AMBERFIELD

Civil Infrastructure Responses to
HCC Further Information Request

Weston Lea Limited

CLIENT	Weston Lea Limited
PROJECT	Amberfield
HG PROJECT NO.	9820-141842-01
HG DOCUMENT NO.	R002v1-AK141842-s92-Final
DOCUMENT	Civil Infrastructure Responses to HCC Further Information Request

2.20 ITEM 17

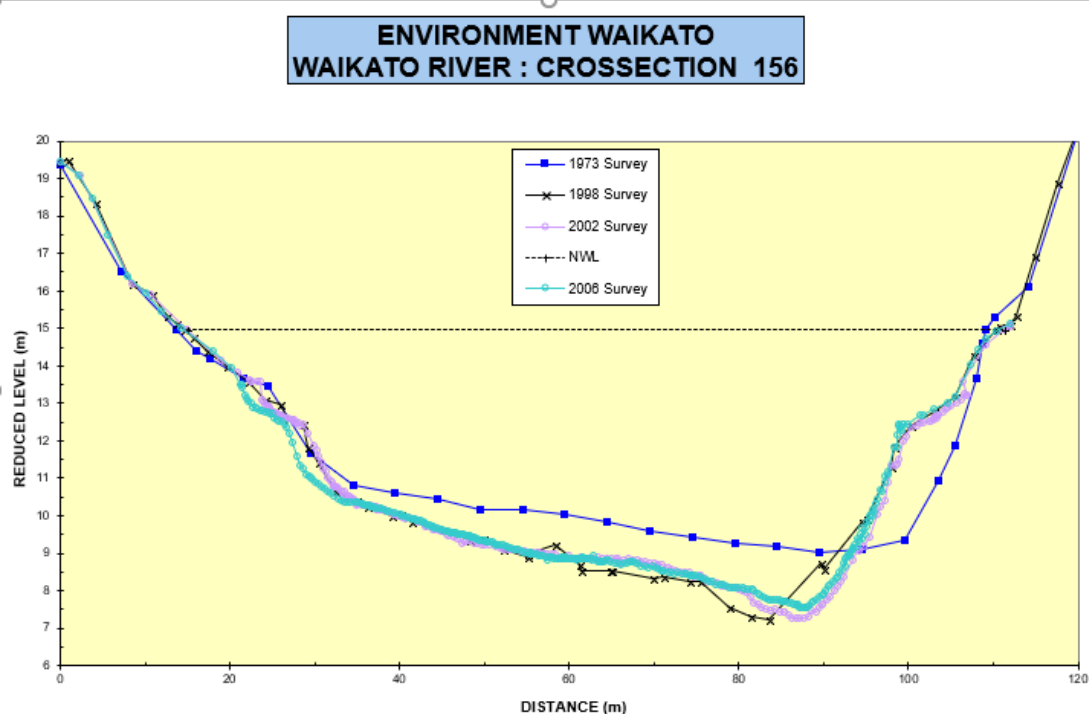
Waikato River – Adoption of 1m Freeboard Allowance for Climate Change

Please confirm the basis for the 1m freeboard adopted to assume a climate change.

As discussed in Section 3 of the Waikato River Adare Flood Hazard Report prepared by Awa Ltd and appended to the Application as Appendix R, an allowance of 1m was recommended as an allowance for the effects of climate change on flows in the Waikato River. The river has a top water width of 120m at a typical cross section (i.e. at the wastewater pump station 4 site at the 1% AEP flood level (see cross section below):

largest flow recorded since 1975, which was 800m³/s, with a TWL of RL 16.75 at the Victoria Street Bridge in Hamilton indicates a manning's "n" value of 0.05 in a flood event, which seems reasonable for this scale of river and the bank characteristics. Applying this value and a slope of 1:4,700 for a peak flow, with a cross sectional area of 923m² at a TWL of RL19.5, we estimate the 1% AEP flow to be 1,100m³/s at the site. The additional allowance of 1m for climate change and freeboard would result in a peak flow of approximately 1,240m³/s, which is a 13% increase on the "no climate change" model results.

Therefore, in assessing the appropriateness of the 1m allowance for climate change, we consider an allowance for an additional 13% flow in the Waikato River, which is highly controlled by the hydro dams, is reasonable.

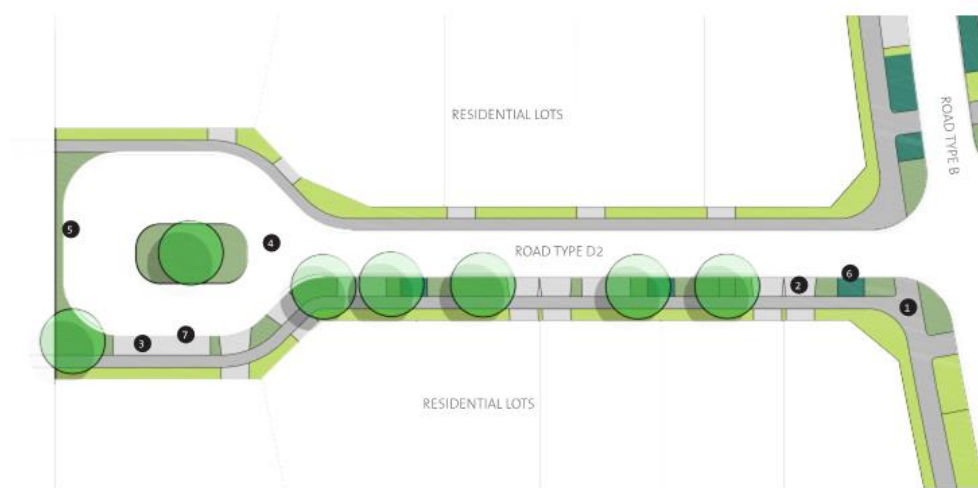
Road and Stormwater Design

The ITA states that to reduce the number of intersections along Peacockes Road and to achieve appropriate separation between intersections, some properties between the north-south local road and Peacockes Road will be served by either cul-de-sacs or accessways to rear lots. Two of the proposed cul-de-sacs will have the head of the cul-de-sac adjacent to Peacockes Road.

The Urban Design Report (Appendix D) states that connectivity between Peacockes Road and the two cul-de-sac roads will be for pedestrians (and cyclists) only, and from an urban design perspective will provide visual connections from Peacockes Road into the site. Please provide a concept design for the landscape treatment (hard and soft landscaping) and the pedestrians connection taking into account the level difference between the roads and available land area outside the carriageway and footpath to better understand the urban design outcome.

Refer to drawing A17134_210-216_Landscape_Street_Typical_Plan_Cul_de_Sac_Rev_B (contained in Appendix F of the resource consent application) regarding the landscape treatment which has been designed with footpaths either side of the cul-de-sac head, a central island and amenity planting. An extract from this drawing is provided below.

Regarding the change in height and connection between the cul-de-sac and the finished contours, the proposed contours are shown on drawing 141842-SK250. Grades are approximately 9% for the northern cul-de-sac head and 2% for the southern cul-de-sac head. The change in heights do not require any retaining, stairs or other forms of level treatment.
